UNITED STATES PATENT AND TRADEMARK OFFICE

APPLICATION NO.	FILING DATE	FIRST NAMED INVENTOR	ATTORNEY DOCKET NO.	CONFIRMATION NO.
10/796,450	03/09/2004	David G. Wilson	DGW-100US	2398
23122	7590	09/30/2005	EXAMINER	
RATNERPRESTIA			THOMAS, COURTNEY D	
P O BOX 980			ART UNIT	
VALLEY FORGE, PA 19482-0980			PAPER NUMBER	
			2882

Office Action Summary	Application No. 10/796,450	Applicant(s) WILSON, DAVID G.	
	Examiner Courtney Thomas	Art Unit 2882

DETAILED ACTION***Drawings***

5. **Figure 1 - Cephalometric Radiology Apparatus - U.S. Patent 5,454,023 to Asikainen**

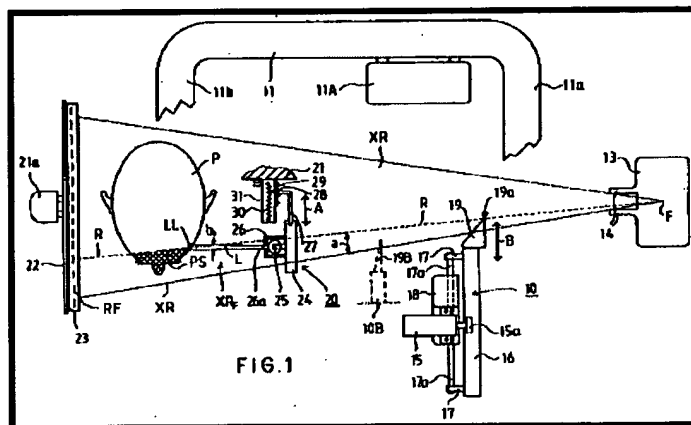
6. As per claims 1, 13, 14, 20, 21, Asikainen discloses an apparatus (and corresponding method of use) comprising: an X-ray generator (13); an X-ray detector (23); a support structure (12-not shown above); a collimator (14); a soft tissue filter (19), wherein the soft tissue filter screen is independently adjustable relative the collimator (14); and a mounting component (10)

10. **As per claims 2-6, 10, 22, 23 and 27-30**, Asikainen as modified above, discloses an apparatus wherein the soft tissue filter screen is L-shaped; is adjustable relative to the collimator (14) in the anterior/posterior and superior/inferior directions (see direction B in Fig. 1, above); is a unitary component; is beveled (see Fig. 4A, above) and adapted to enhance radiograph images of the neck contour of a patient.

17. **As per claims 15-17, 32 and 33**, Asikainen as modified above, discloses an apparatus further comprising at least one positioning light (25) to identify an optimum position of the soft tissue filter screen (see Fig. 1, above; see also column 3).
